Remarks

9/650,787

FIG. 20
(PRIOR ART)

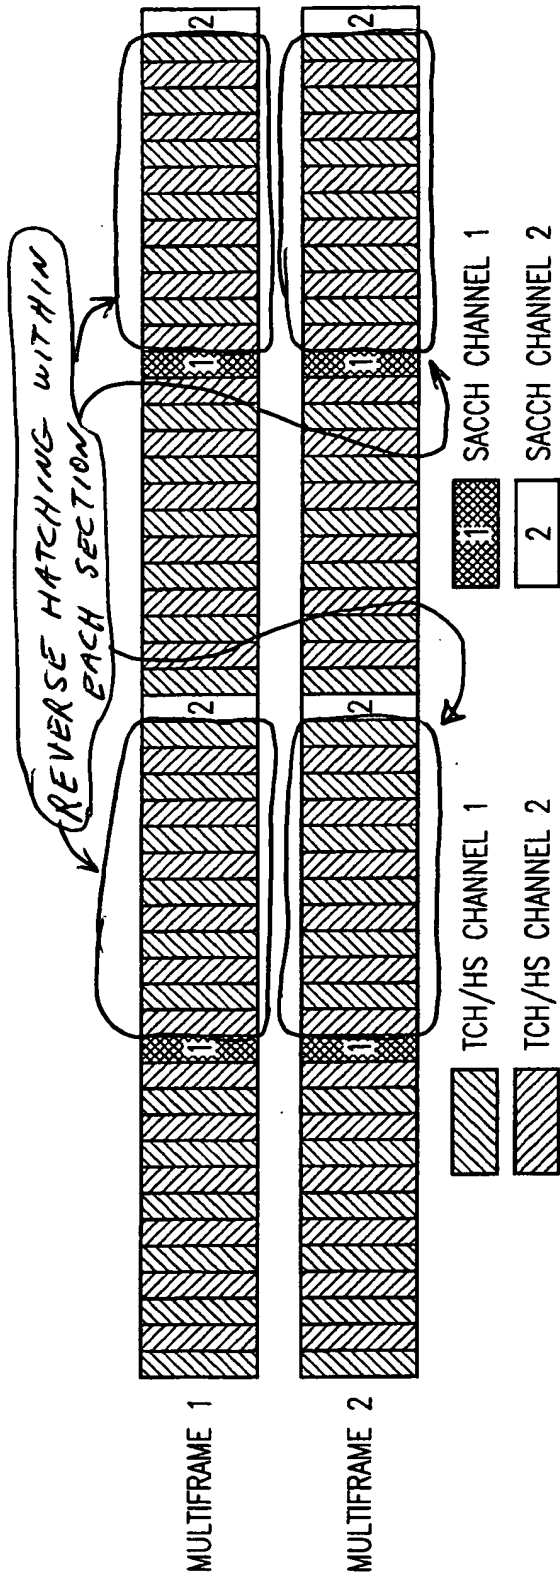
Figures 1 and 20 were objected to as not having "Prior Art" as a legend. The attached proposed correction to figure 20 illustrates adding of this legend. Applicant respectfully traverses the requirement of adding the legend "prior art" to figure 1 since this figure illustrates a preferred embodiment of the present invention. On page five of the Detailed Description section of the subject application it is stated: "Referring now to FIG. 1, a system 1 is shown. System 1 in a preferred embodiment, is a... (GERAN) as described herein." Clearly figure 1 supports the system as referenced in the claims and provides apparatus with new functions defined in accordance with the claims. Thus, claim 1 does not show only that which is old since the new apparatus features associated with the present invention are contained within the structure shown in figure 1. Approval of the proposed drawing correction to figure 20 and withdrawal of the requirement to add a "prior art" legend to figure 1 are requested.
